RAI Volume 3, Chapter 2.2.1.3.7, First Set, Number 1:

Describe how UZ transport model results support the integration of transport processes in terms of the UZ barrier components and the relative importance of the transport processes.

Figure 1.1. Tracer Concentrations in Applied Infiltrating Water and Seepage Water in Alcove 1

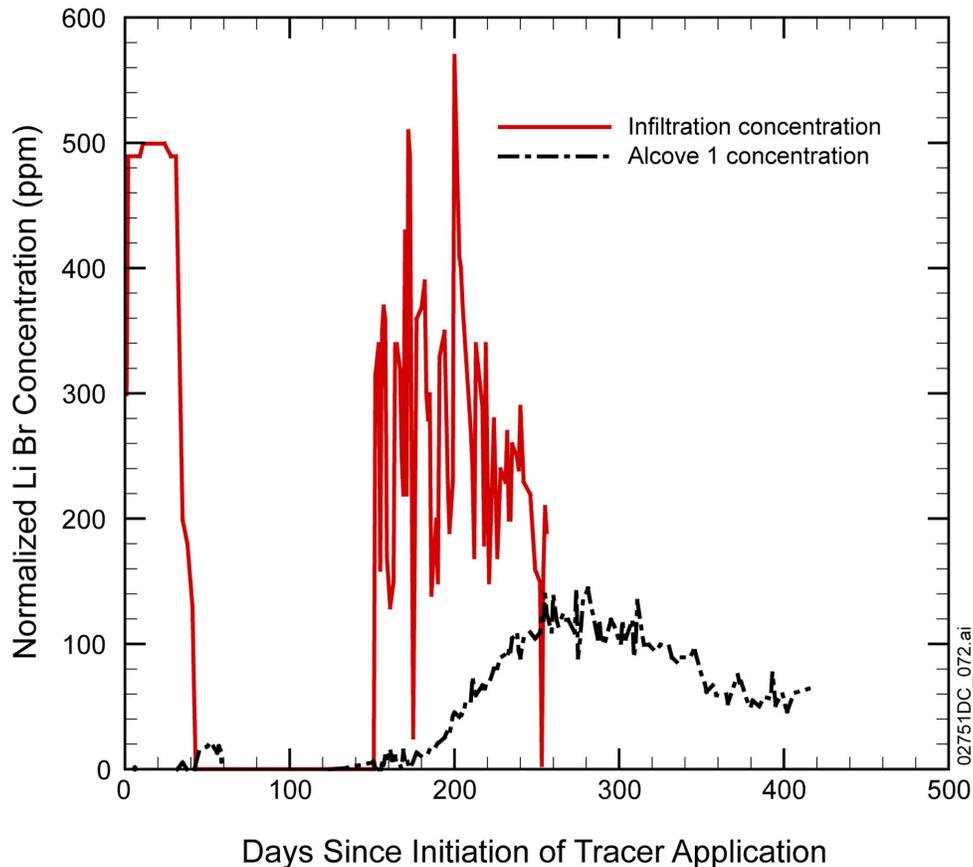
Basis: Figures 2.3.8-34 and -35, referred to in Section 2.3.8.4.4.5 of the SAR, show applied bromide tracer concentrations that fluctuated irregularly from 150 to 600 ppm over a period of approximately 100 days and observed seepage tracer concentrations that increased from 0 to 150 ppm in a relatively smoother curve approximately one month after the initiation of the tracer application. It is not apparent how much retardation of the tracer occurred relative to the infiltration rate, why the applied tracer concentration varied so irregularly as part of the experiment, how the fluctuating initial concentration was addressed in the interpretation of results and subsequent modeling, or what percentage of tracer mass was recovered relative to that applied. This information is needed to verify compliance with 10 CFR Part 63.114(g).

Tracer transport rates in Alcove 1 are based on tracer breakthrough behavior shown in Figure 1.1. The time origin on this plot corresponds to May 18, 1999, about 14 months after the beginning of water release into the infiltration plot at Alcove 1. This analysis focuses on the second tracer application because of the stronger response in the tracer concentrations measured in Alcove 1 seepage water as compared with the first tracer application. The second tracer injection began on day 152 on Figure 1.1. Tracer injection concentrations are highly variable during the second tracer application (see Section 1.4), but an average injection concentration was about 266 ppm. The tracer response reached a peak concentration in Alcove 1 seepage water of about 133 ppm at about day 255. After this peak concentration is reached, the tracer concentration in Alcove 1 seepage water began to decrease in response to the termination of tracer in the infiltrating water at the ground surface.

One characteristic transport time is the median transport time, which is the time required for the downstream tracer concentration to reach 50% of a sustained tracer concentration in the introduced water at the ground surface. The breakthrough curve reaches the 50% relative concentration level about 103 days after the beginning of the second tracer application to the infiltration water (Figure 1.1). Another characteristic transport time is the point where the slope of the concentration-time curve changes significantly at about 180 days, or 28 days after the beginning of tracer application. This time will be referred to as the “breakthrough” time. The fraction of tracer that arrives at or before the breakthrough time is clearly quite small and, therefore, is suitable to characterize the fastest observed tracer transport.

The lithium bromide tracer concentrations applied at the ground surface for the Alcove 1 transport tests also displayed relatively high amplitude fluctuations, from about 150 to 600 ppm as shown in Figure 1.1. The samples collected to analyze the bromide concentrations were taken from the drip lines used to distribute the source water and tracer in the infiltration plot. The bromide concentration fluctuations were caused by: (1) supersaturation of bromide solution resulting in precipitation of bromide in the solution supply bucket; (2) incomplete mixing of the lithium bromide in the supply solution bucket; and (3) batch bromide analyses that introduced a time delay (on the order of a week) in correcting deviations in solution concentration.

Figure 2. Cumulative Mass Released of ⁹⁹Tc and ²⁴²Pu from the Engineered Barrier System, Unsaturated Zone and Saturated Zone for Realization 4,641 of the Seismic Ground Motion Modeling Case for the 1-Million-Year Period after Repository Closure (SAR Figure 2.4-108)

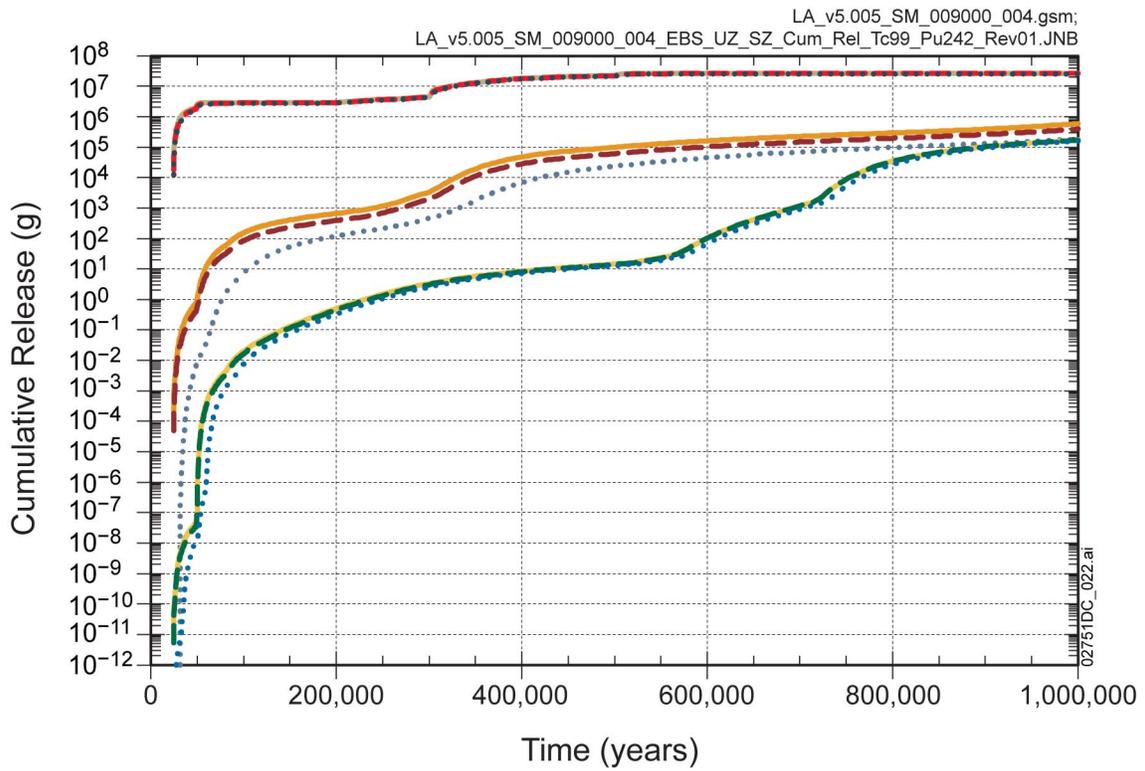
Basis: Modeling results presented in the SAR indicate that plutonium is transported more readily through the UZ as a solute or reversible colloid than as an irreversible colloid. The modeled arrival time of irreversible colloids is longer than and contributes less to ²⁴²Pu activity releases from the UZ than the dissolved and reversible colloids in the UZ (e.g., SAR Fig. 2.4-108). However, results presented elsewhere in the SAR indicate that irreversible colloids have short travel times in the UZ (e.g., SAR Section 2.3.8.5.4). The information is needed to verify compliance with 10 CFR 63.114(a) and (b).

SAR Figure 2.4-108 (see Figure 2) contains three sets of curves. One set is comprised of the EBS, unsaturated zone, and saturated zone cumulative releases of ^{99}Tc . The second set is comprised of the EBS, unsaturated zone, and saturated zone cumulative releases of ^{242}Pu migrating as a combined dissolved phase and reversibly sorbed to a smectite colloid phase. The third set is comprised of the cumulative EBS, unsaturated zone, and saturated zone releases of ^{242}Pu irreversibly sorbed to both waste-form colloids and iron oxyhydroxide colloids. The irreversibly sorbed ^{242}Pu travels through the Lower Natural Barrier (unsaturated zone and saturated zone features) as both slow (retarded) and fast (unretarded) irreversible colloids (SAR 2.3.8.5.4). The curves in SAR Figure 2.4-108 designated as “irreversible on colloids” represent the sum of the releases from the slow and fast irreversible colloids.

The initial part of the cumulative breakthrough curves must be examined to compare the relative travel times of ^{242}Pu migrating as dissolved and reversibly sorbed in local equilibrium (^{242}Pu (aqueous)) with the travel time of ^{242}Pu migrating as irreversibly sorbed onto colloids (^{242}Pu (irreversible on colloids)). To do this, it is necessary to expand both the y- and x-axis scales of SAR Figure 2.4-108 so that the entire transport history of both sets of ^{242}Pu transport curves can be seen (see Figures 3 and 4). As can be seen in Figures 3 and 4, EBS releases for both ^{242}Pu (aqueous) and ^{242}Pu (irreversible on colloids) actually begin at the same time (24,500 years), which is the time of the first damaging seismic event to codisposal waste packages. This was not apparent in SAR Figure 2.4-108 because of the axis scaling. Also, the early-time cumulative mass for irreversible colloids released from the EBS is much lower than the aqueous phase releases, which apparently causes the aqueous phase arrival times to appear earlier on SAR Figure 2.4-108 with the particular x- and y-axis scales shown in that figure. The expanded scales shown in Figures 3 and 4 eliminates this graphical effect. Note that on Figures 3 and 4 the unsaturated zone releases appear to start at the same time as the EBS releases, which reflects the fact that the cumulative release curve is integrated over 500-year timesteps at 24,500 years, which is too large to distinguish initial EBS releases from initial unsaturated zone releases. These initial unsaturated zone releases represent mass transported with a relatively fast travel time through the northern portion of the repository for both aqueous ^{242}Pu and irreversible ^{242}Pu .

The much larger EBS aqueous release compared to irreversible colloid release in SAR Figure 2.4-108 is attributable to differences in the transport properties between aqueous and colloidal phases for early diffusion-dominated EBS releases from damaged waste packages in the seismic ground motion modeling case (i.e., diffusive transport of colloids is a very slow transport mechanism), which means that ^{242}Pu release on irreversible colloids is very small. The relative difference in the amount of mass transported from the EBS as dissolved/reversibly-sorbed versus irreversibly sorbed can be seen in SAR Figures 2.4-104 and 2.4-106. Also, as is apparent from these figures, these early releases of irreversible colloids are only from codisposal waste packages (which are the only breached packages at early times in this single realization) and therefore they are waste-form or glass colloids. Furthermore, as shown in SAR Figure 2.4-104, the concentration of ^{242}Pu irreversibly attached to codisposal glass waste-form colloids is very low in the first 50,000 years, indicating an unstable colloid suspension due to the high ionic strength, which is characteristic of diffusive release scenarios. This low concentration implies much lower release rates than for aqueous ^{242}Pu . The high ionic strength in the
